Project T10/1760-D

Revision 14
28 January 2008

Information technology - Serial Attached SCSI - 2 (SAS-2)

Summary of Comments on Serial Attached SCSI - 2 (SAS-2) Standard

Figure 50 — Expander route index order example

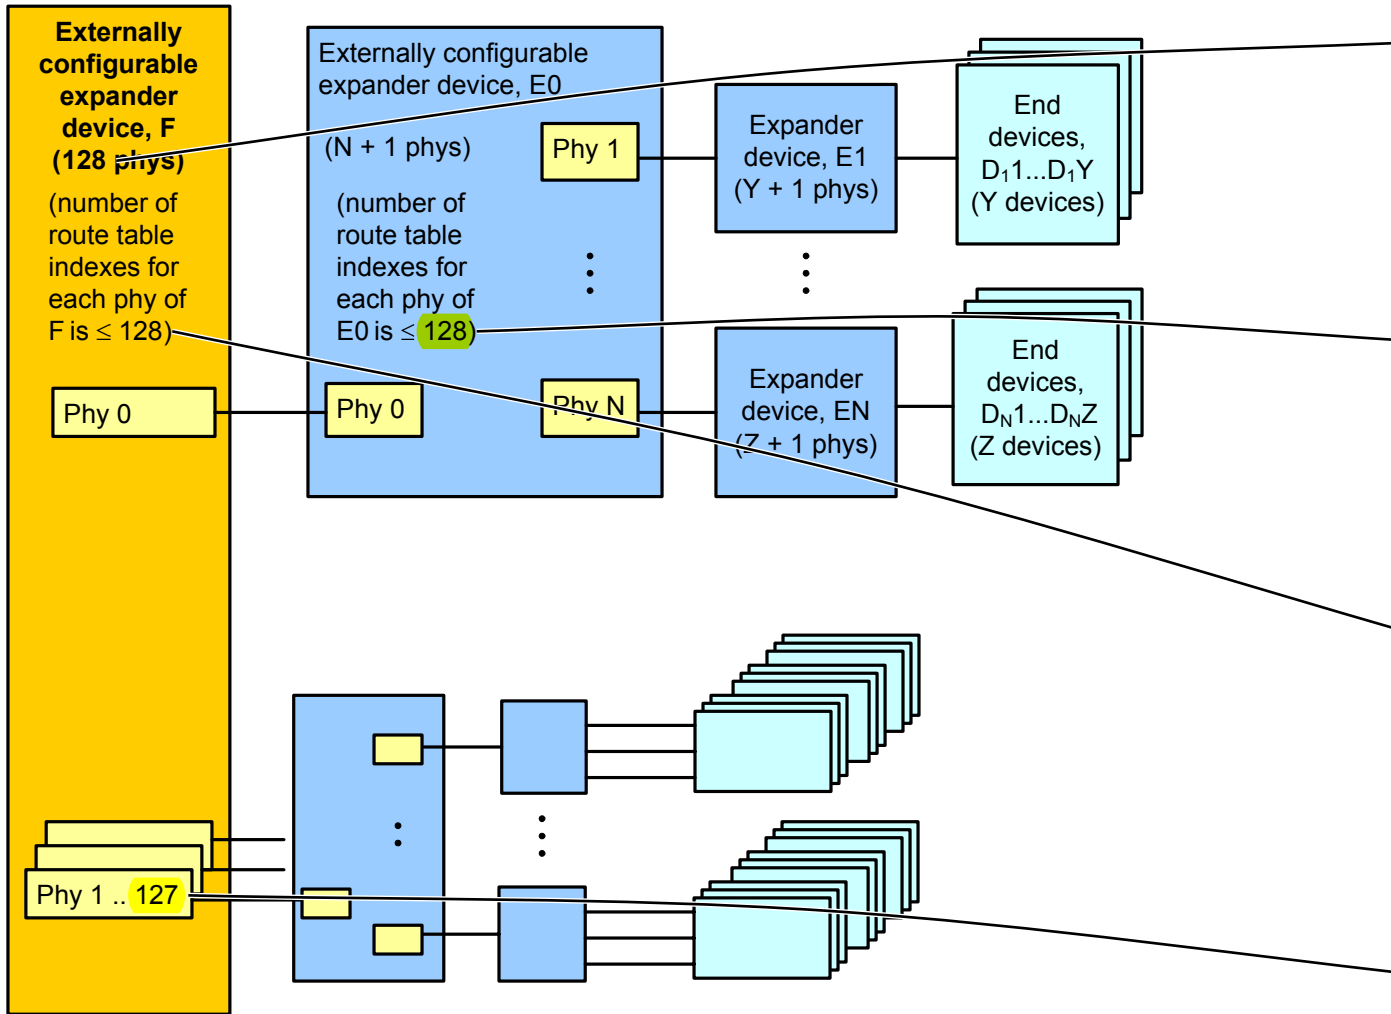
in figure 50, not table 50: 128 to 255, deleted two unnecessary sentences

Figure 155 — SP (phy layer) state machine - SAS speed negotiation states

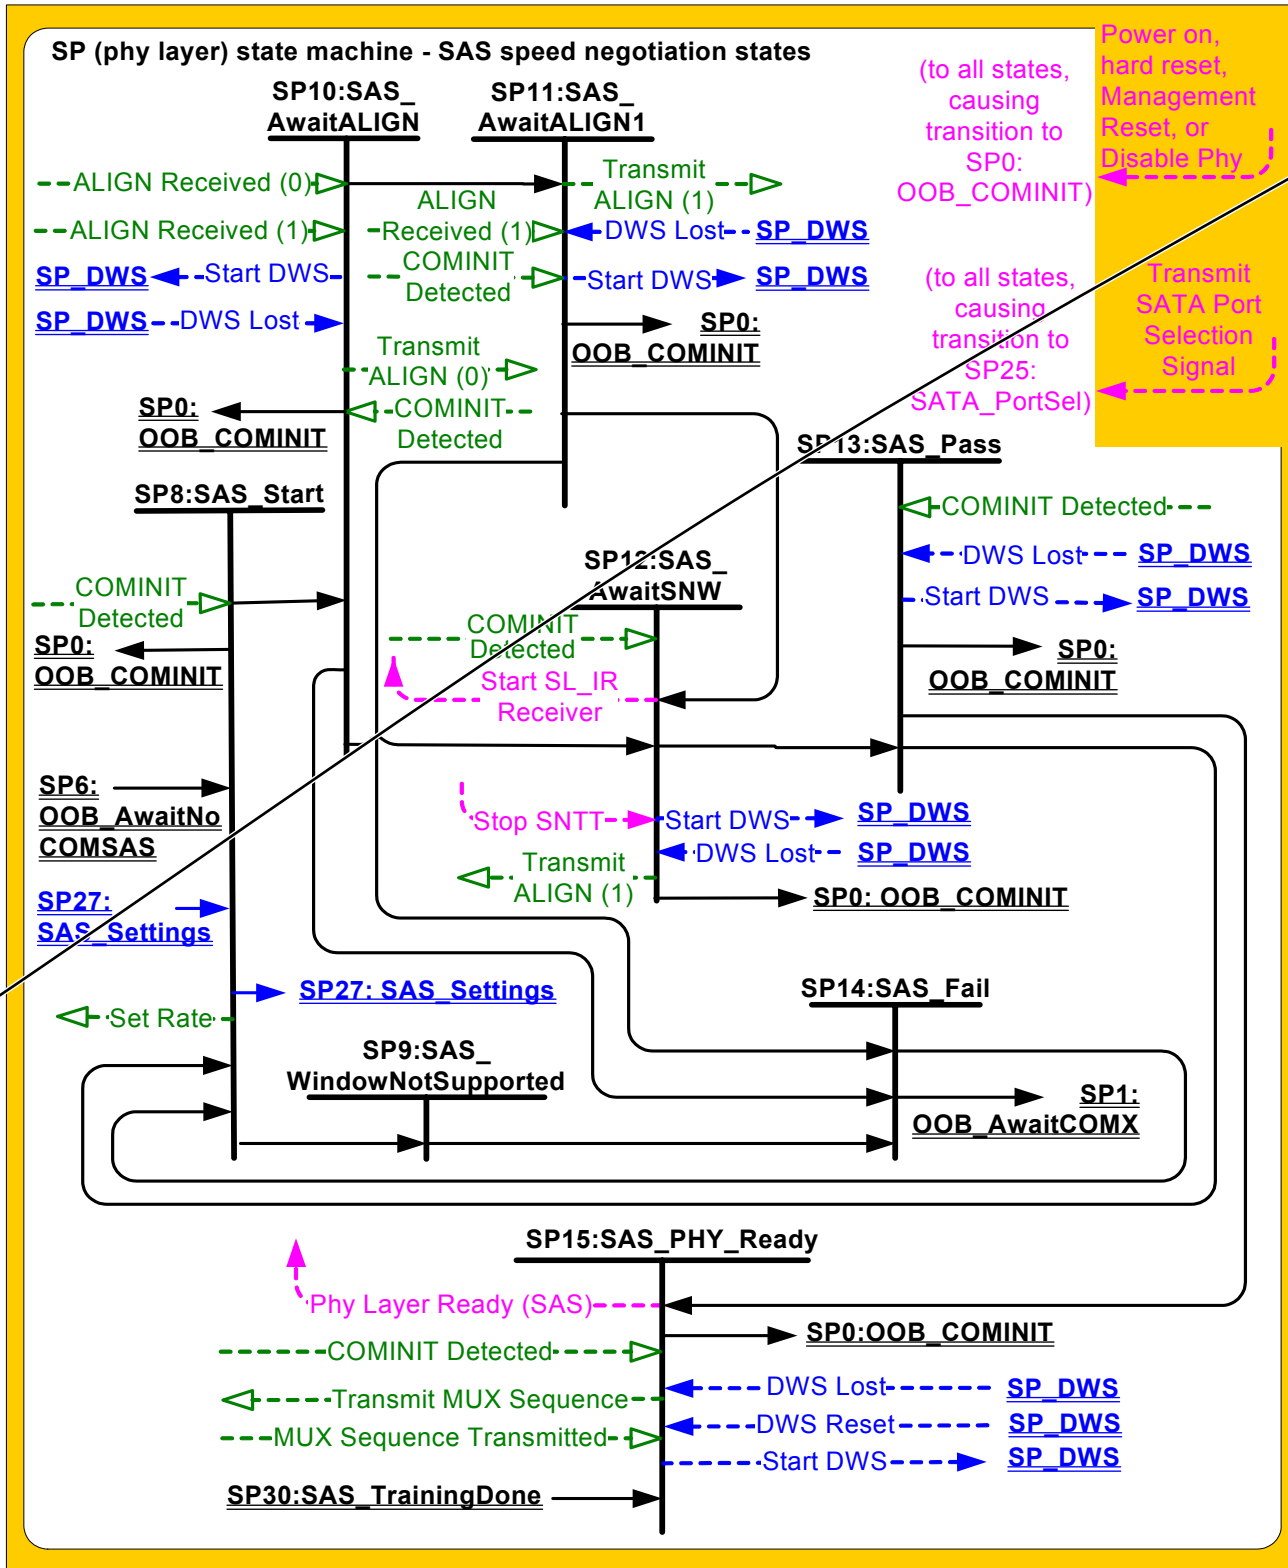
and performs
s/b
and the states in the state machine perform

Figure 157 — SP (phy layer) state machine - SATA host emulation states

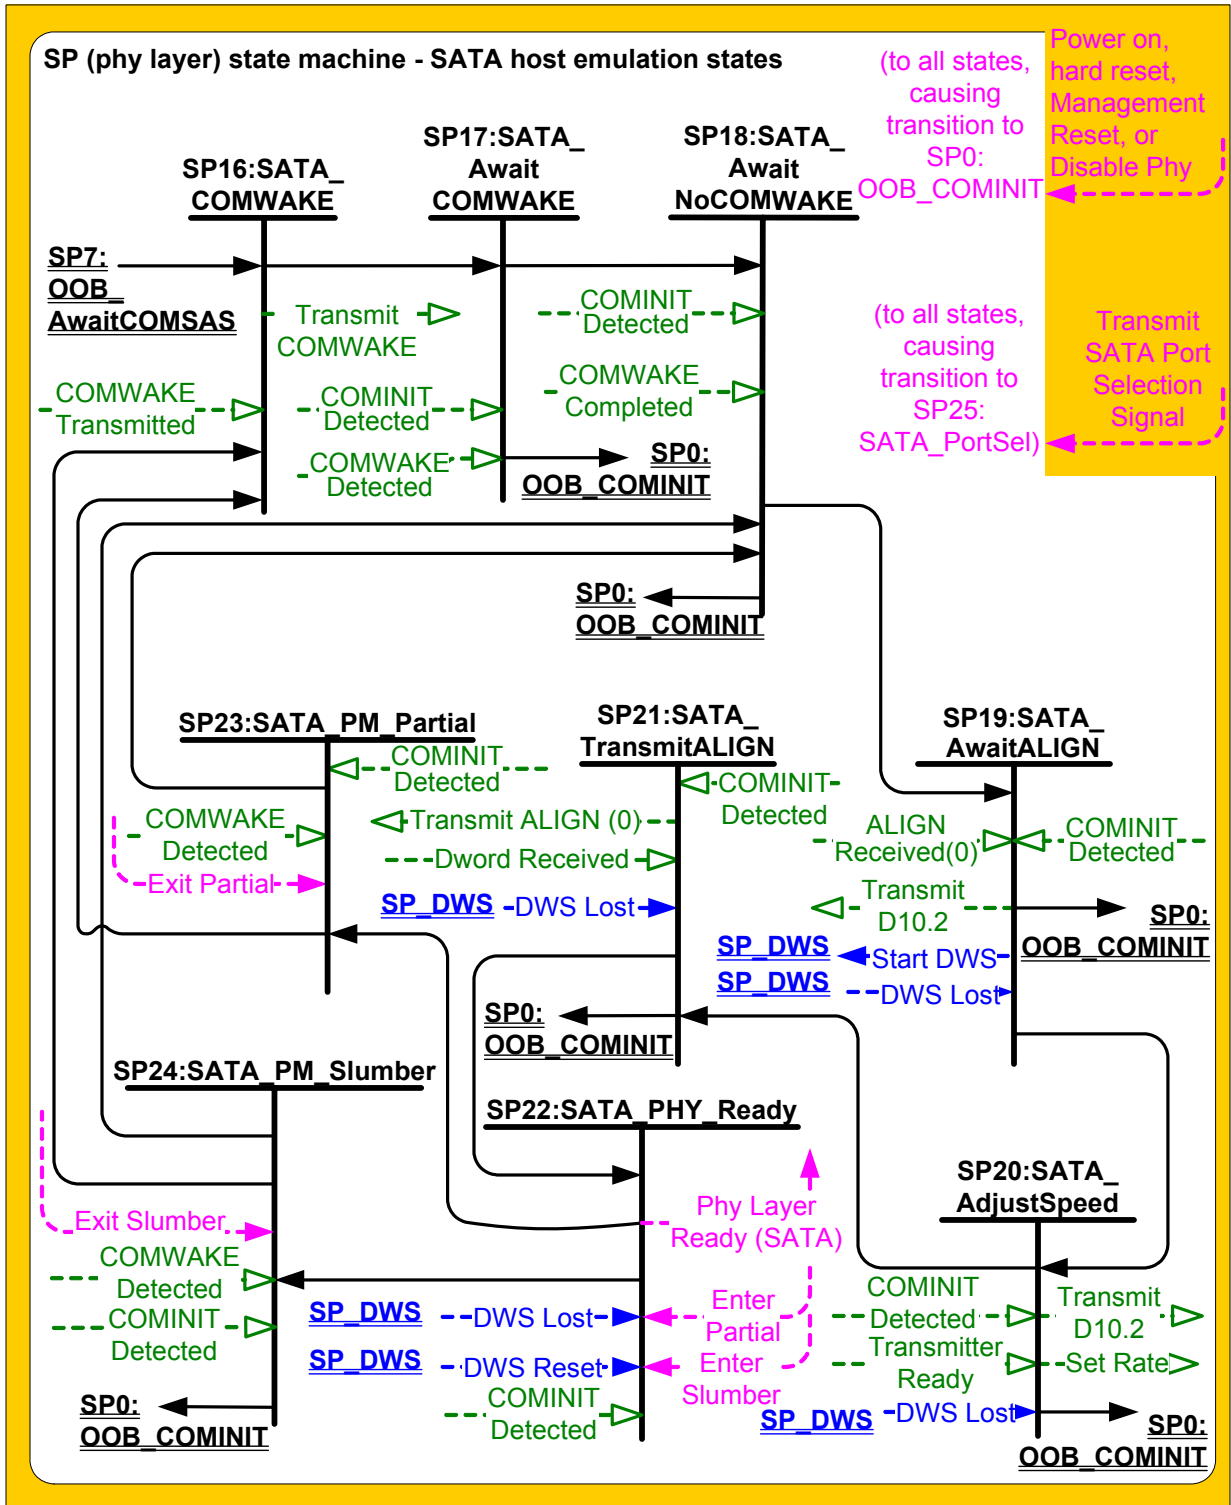
Delete "in this standard" which is awkward wording

Figure 197 — STP flow control

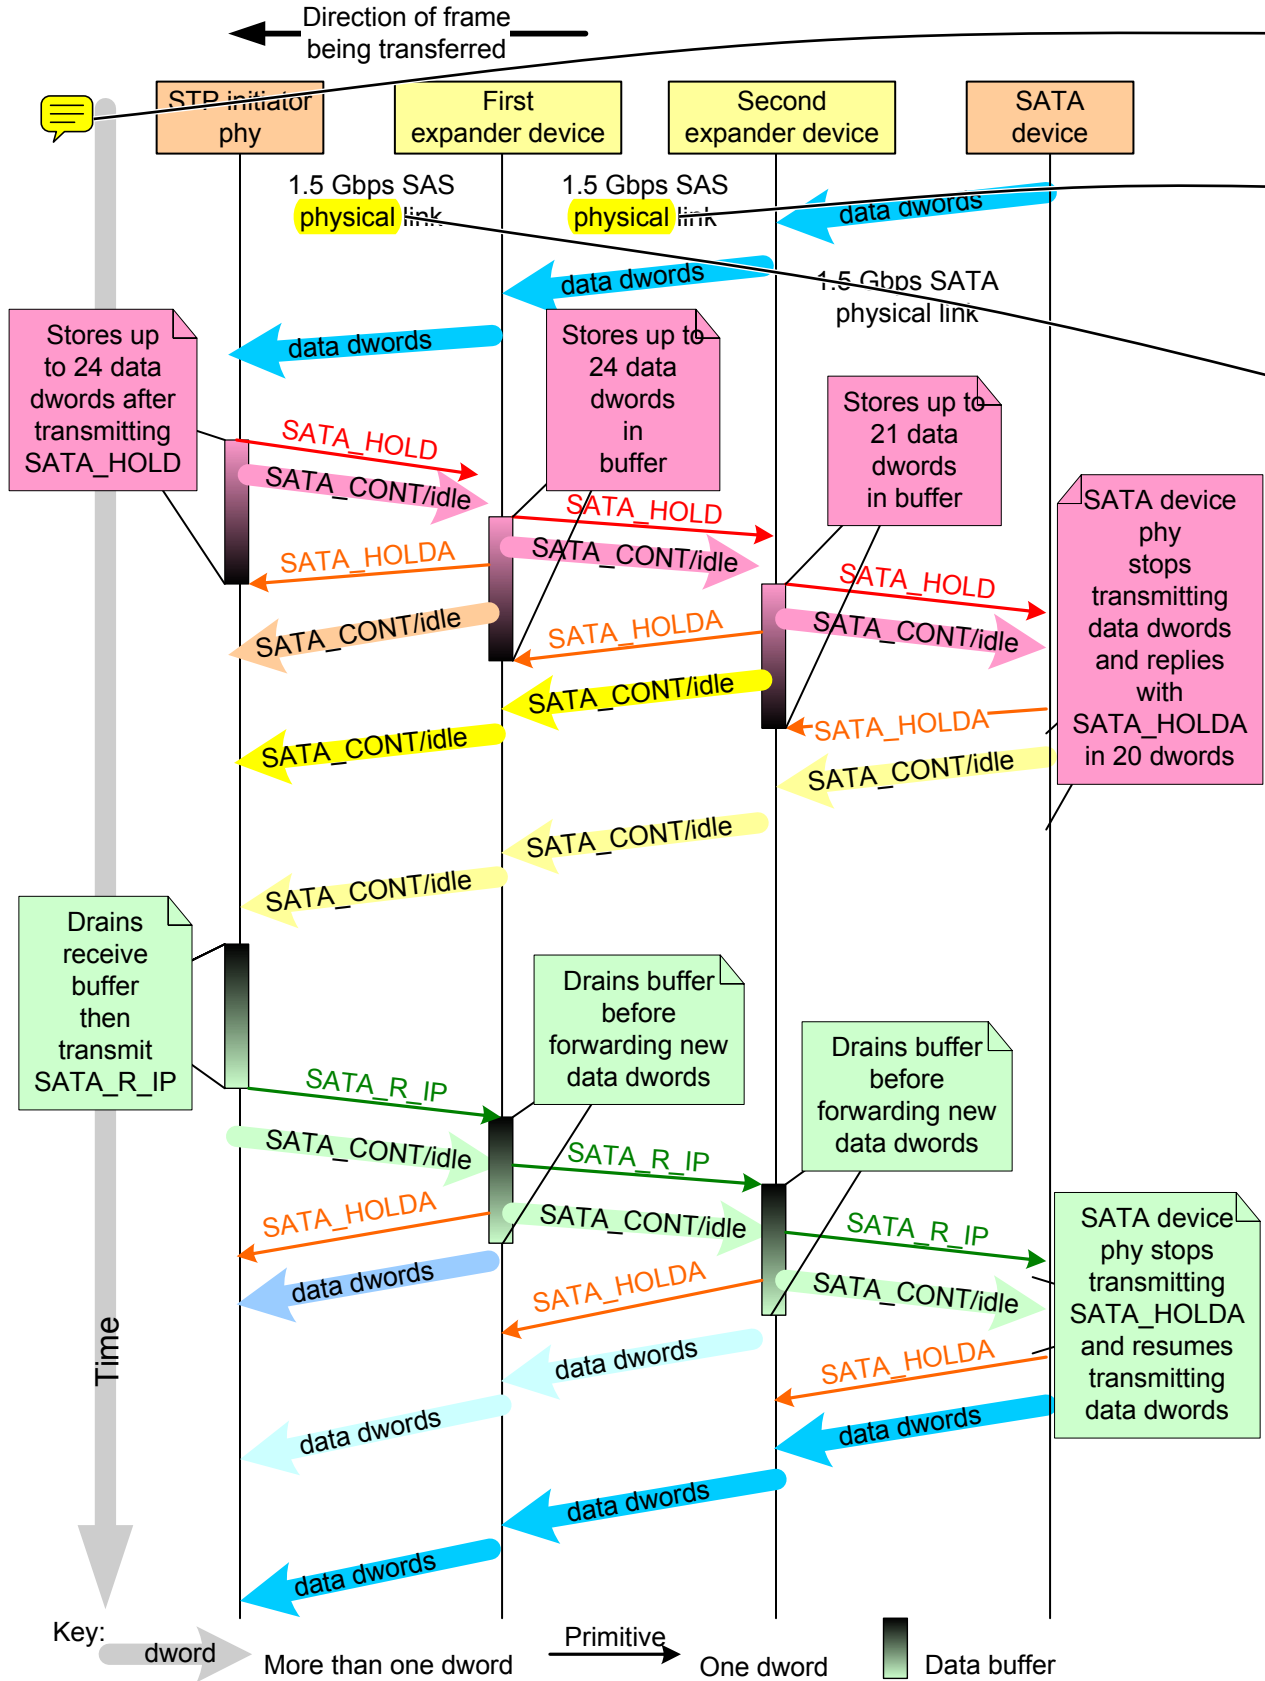
(from discussion with Jeff Gauvin, LSI)
